570 MERCER

SEATTLE, WA 98109
SDCI# 3035337-LU

DESIGN REVIEW BOARD:
DESIGN RECOMMENDATION MEETING #2
FEBRUARY 16, 2022

MASSING OFFSETS CONCEPT

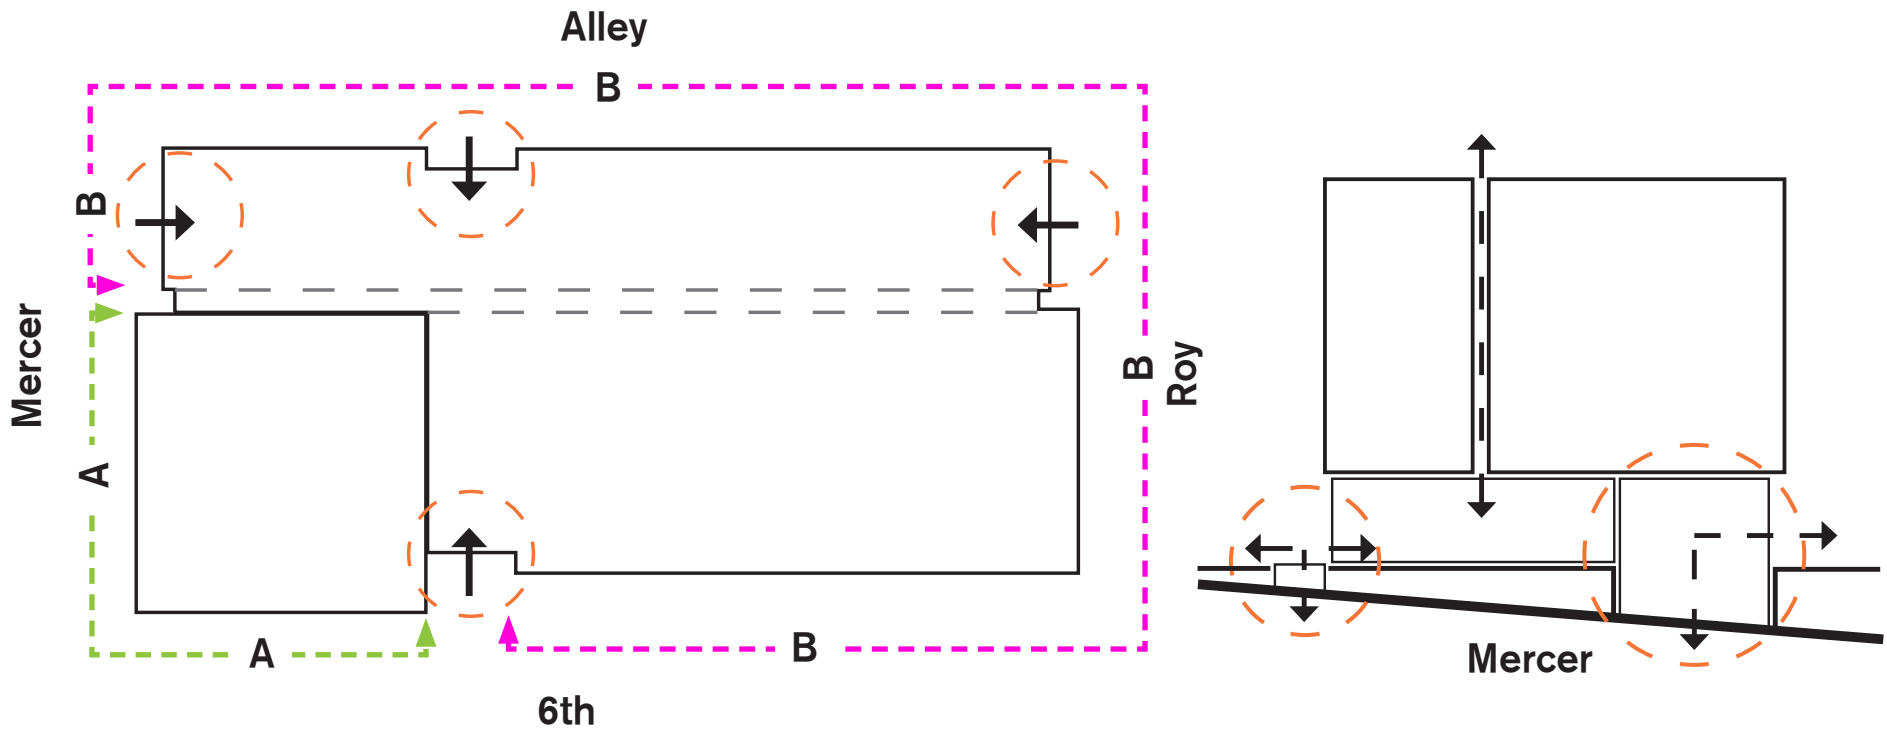
- EDG1**
- Staff appreciates...the intent to create a composition of distinctly legible elements but finds the **very small changes in plane, parapet height and exterior expression to be insufficient to achieve this result**. The architectural detail and treatments should be accompanied by both **massing moves and articulation of the facades**. (DC2-A, DC2-B)

- Site locaiton borders **Uptown** and **SLU** and sets up a **massing parti** that reacts to 6th & Roy differently than Mercer.
- **Massing offsets** create significant **physical breaks** in the facade to provide opportunities for **clear and deliberate transitions** between facade expressions.
- **Expression A** represents a gateway to **Uptown** from **SLU** and provides new and heroic openings in the Mercer retaining wall to give **new pedestrian access through a stair climb on the west** and a **lower building entry on the east** that physically connects Mercer to 6th.
- **Expression B** represents the frontage to **Uptown** and provides for varying levels of **massing offsets** that includes **two/four story datums, setbacks at street level, balconies, and variations in fenestration patterns** to create transitional architecture.

CONTEXTUAL DIAGRAMS

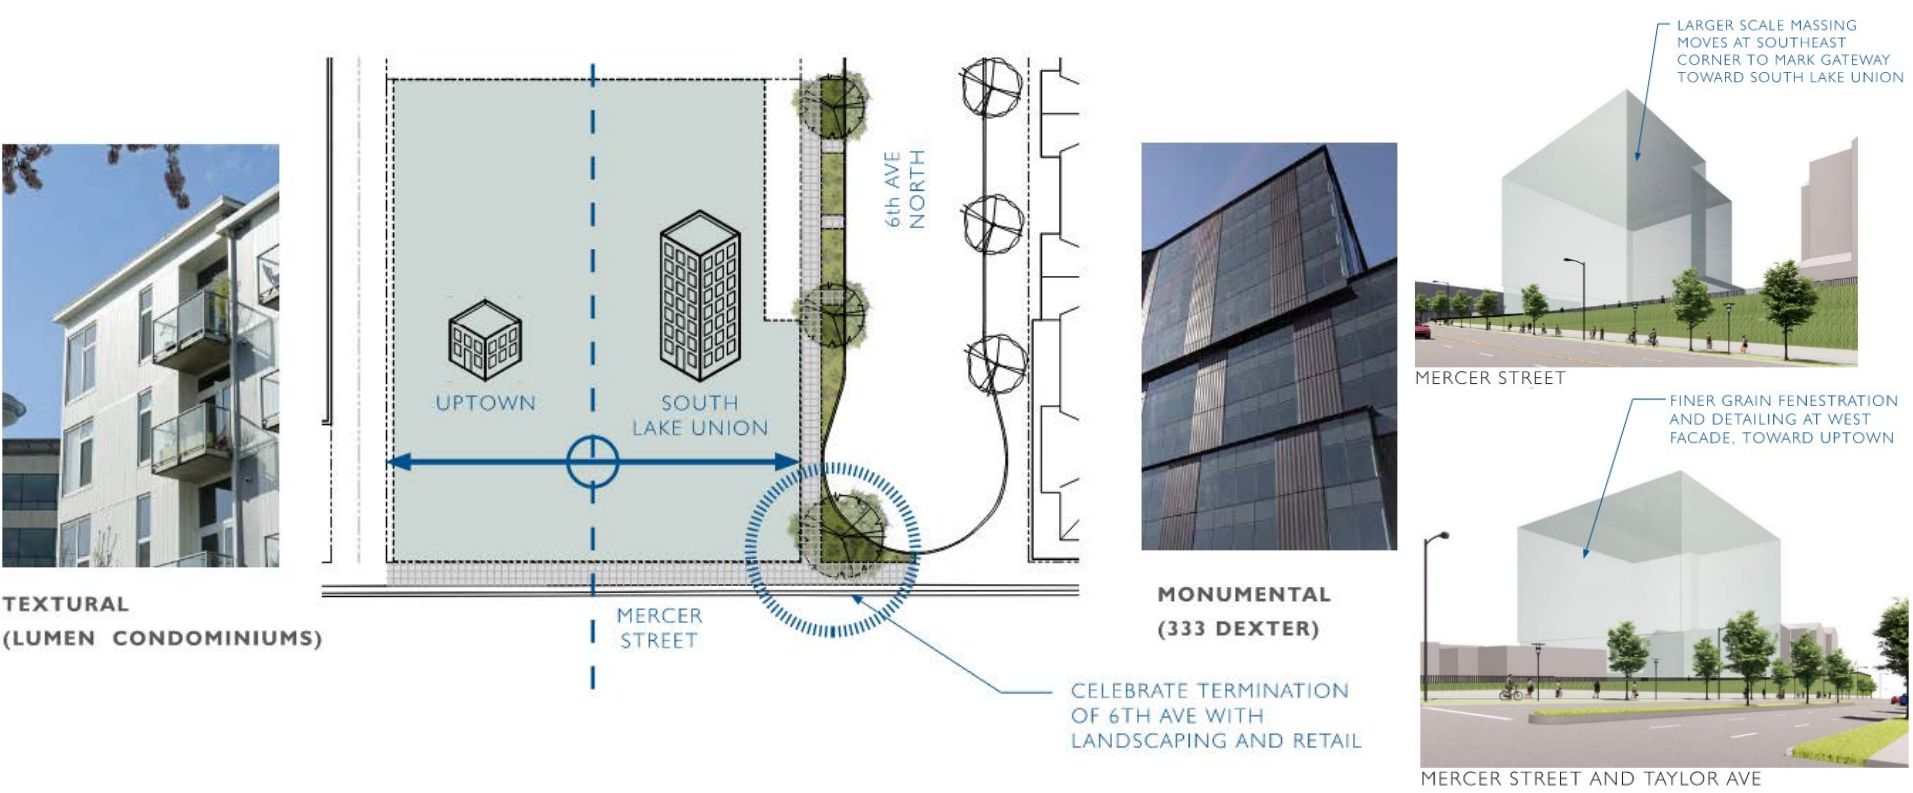
- The Board agreed that the **connection between context and architectural composition was unclear** on the two less-visible elevations at west and north, and that these should be **developed to be both clearly connected to their unique contexts and to the over arching design concept** as articulated on the more prominent south and east elevations. (CS2, CS3, DC2, DC2-B-1)

REC1 PERSPECTIVES FACING NORTHEAST

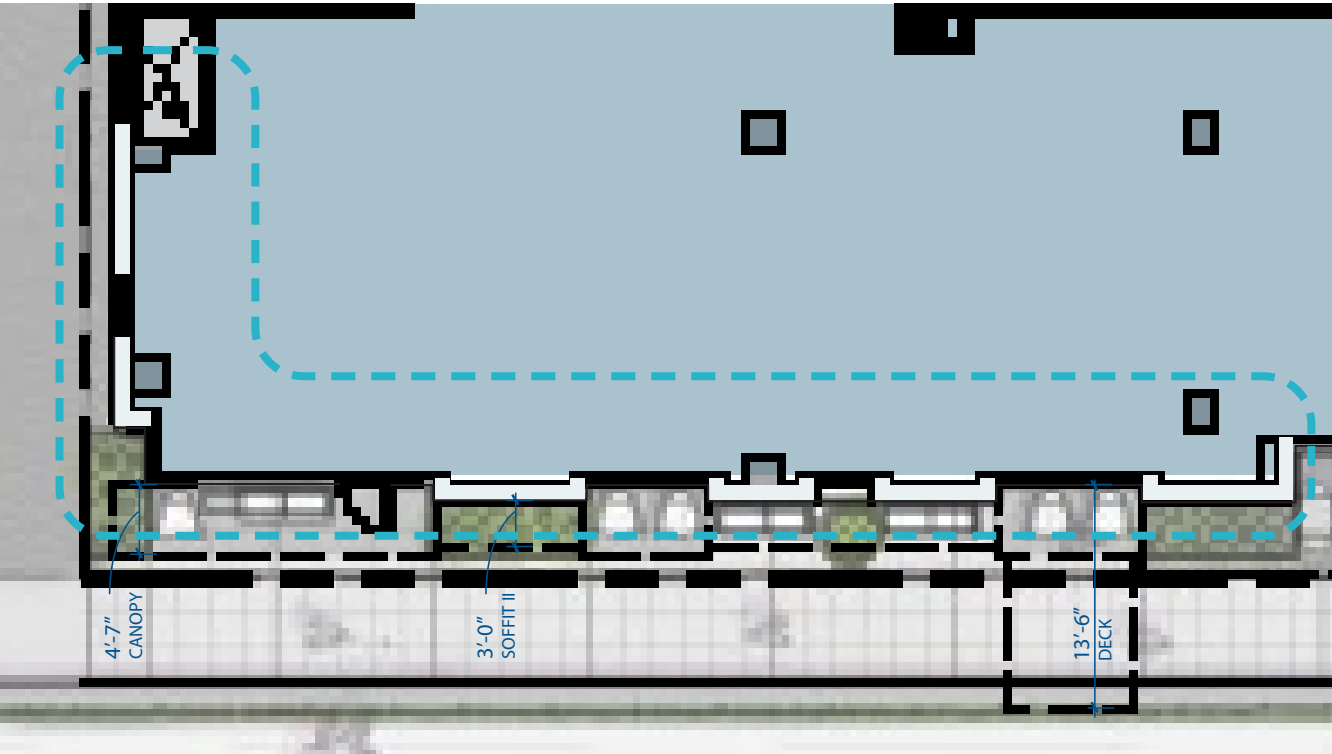
- The Board agreed that the **southwest corner of the project would be highly visible**, particularly to those travelling east, and agreed that the current design at street level **lacked appropriate distinction and appeared disconnected** from the larger architectural composition. (CS2-A, DC2-B)
- The Board **recommended a condition** to revise the composition of the **southwest corner to create greater distinction and cohesion with the larger composition by increasing the degree of transparency at street level** in a manner reflective of the corner above. (CS2-A, DC2-B)

WATER COLLECTION FEATURE

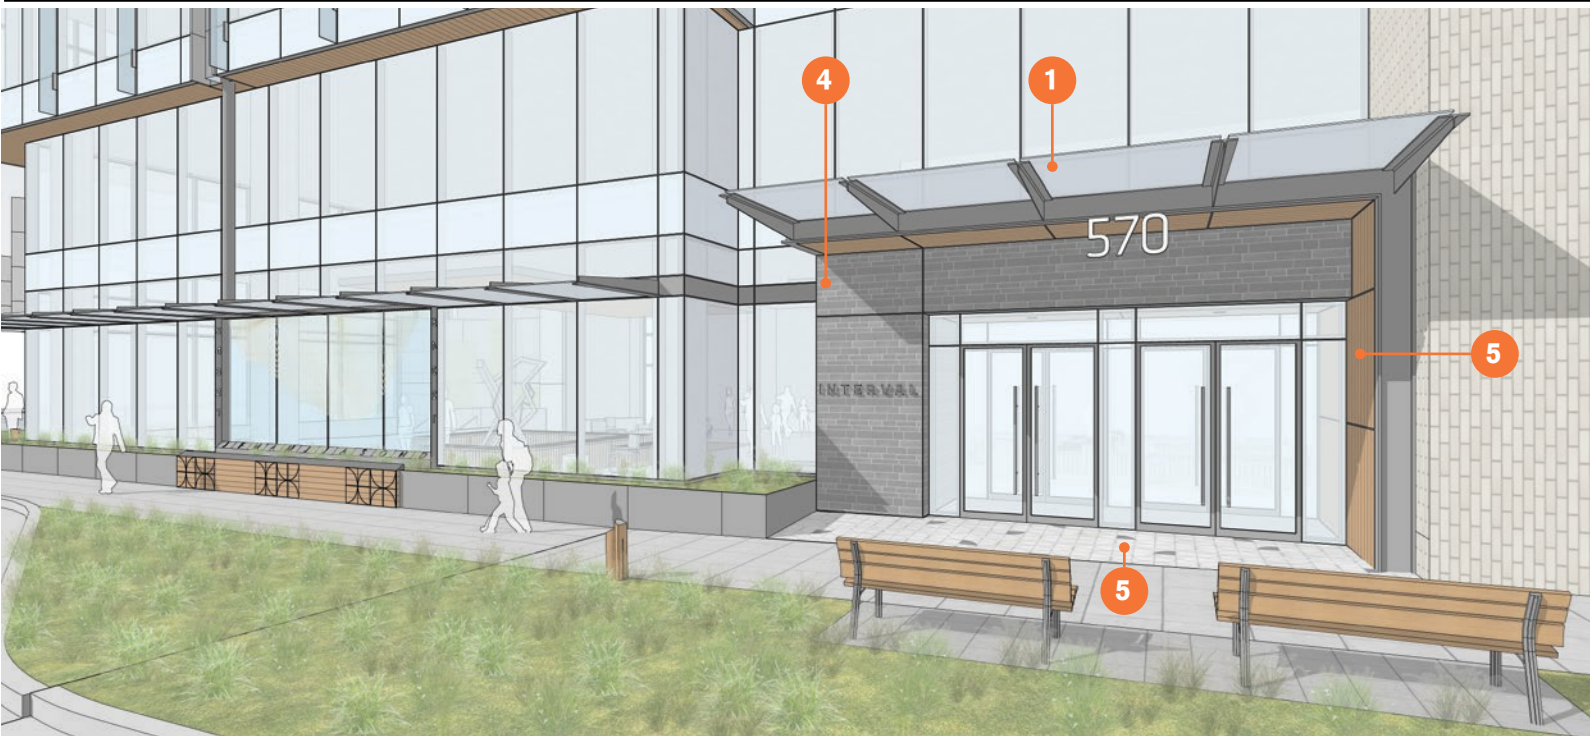
- The Board discussed at length the composition of elements at the **primary entry on 6th Avenue N.** and agreed that the legible sustainability elements driving the story of the building **lacked cohesion at this critical area.** The Board noted in particular the **physical disconnection** of the entry from the conceptually-critical roof water collection system and the potential for **landscape elements to obscure the proposed water feature.** (PL3-A, DC2)
- The Board **recommended a condition to revise the ensemble of elements at the entry** to be more clearly connected to the water system and architectural concept and create a greater degree of identity and distinction at this principal building entrance. (PL3-A, DC2)

The water collection element has been revised to be more prominent along street level. The **collected water form the roof form**, when raining, will be distributed above the canopy and **wash down an etched glass face with an educational graphic** on it. In addition, the **main entry design** has been revised to have a **form that opens up towards the water feature**, and shares a similar use in materials.

- 1 Etched Glass w/Annual Rain Fall Graph
- 2 LED lighting to track the rainfall throughout the year
- 3 Metal Plate Fins w/Rainfall Amount & Month of The Year
- 4 Dark Stone w/Building Sign
- 5 Stained Plank Wood
- 6 Metal & Glass Canopy
- 7 Custom Paver Inlay At Entry Threshold
